# UNITED STATES PATENT AND TRADEMARK OFFICE

APPLICATION NO.	FILING DATE	FIRST NAMED INVENTOR	ATTORNEY DOCKET NO.	CONFIRMATION NO.
10/707,044	11/17/2003	Richard M. Chesbrough	71202-0048	4171
20915 7590 02/27/2007 MCGARRY BAIR PC 171 MONROE AVENUE, N.W. SUITE 600 GRAND RAPIDS, MI 49503			EXAMINER SOLANKI, PARIKHA	
			ART UNIT	PAPER NUMBER
			3737	
SHORTENED STATUTORY PERIOD OF RESPONSE		MAIL DATE	DELIVERY MODE	
3 MONTHS		02/27/2007	PAPER

## Office Action Summary

## **DETAILED ACTION**

FIG. 9

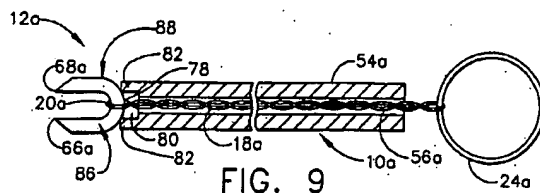
Regarding claims 1-4, 30-33, 35-37, 40, 46, 47, Foerster ('305) discloses means and steps for localizing a tissue mass via a device comprising a marker and a connector separably connected to the marker, wherein the connector may be unthreaded from the marker by pulling the connector (Figs. 9-11). The marker and connector of Foerster ('305) constitute an imaging element and a guide element, respectively, as claimed in the instant application. Foerster ('305) shows that, when the marker is placed within the tissue mass, the connector extends exteriorly of the tissue mass, and when the connector is separated from the marker, no part of the connector extends from the tissue mass (Figs. 10 & 11). Foerster ('305) states that the marker may be visualized via any state of the art imaging system (Abstract).

Regarding claims 14, 26, 55 and 62, Foerster ('305) shows that the connector is a filament (Figs. 9-11).

Regarding claims 3, 39 and 41, the breaking of the connector loop as shown by Foerster ('305) constitutes a cutting mechanism as claimed in the instant application (Figs. 9-11). Foerster ('305) also states that the connector is discarded after it is detached from the marker, which constitutes removing the cut portion of the guide element as claimed in the instant application (§ 0049).

FIG. 10

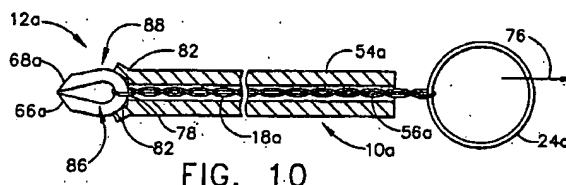
Regarding claims 19 and 58, the connector of Foerster ('305) is coupled to the marker by being threaded through the loop of the marker (Fig. 10).

FIG. 11

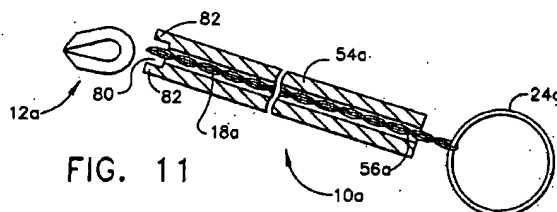
Regarding claim 18 and 57, Foerster ('305) discloses that the connector includes a failure point, at which the element may be separated from the marker after the marker has been placed in the tissue (§ 0020 & 0049, Fig. 11).

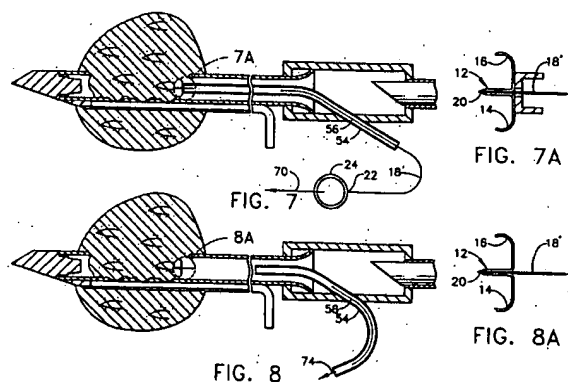
Regarding claims 44 and 45, Foerster ('305) states that entire biopsy instrument may be mounted on a commercially available stereotactic guidance system (§ 0043). The delivery assembly components of Foerster ('305) comprise a self-contained marking apparatus as claimed in the instant application (Figs. 7-8A).
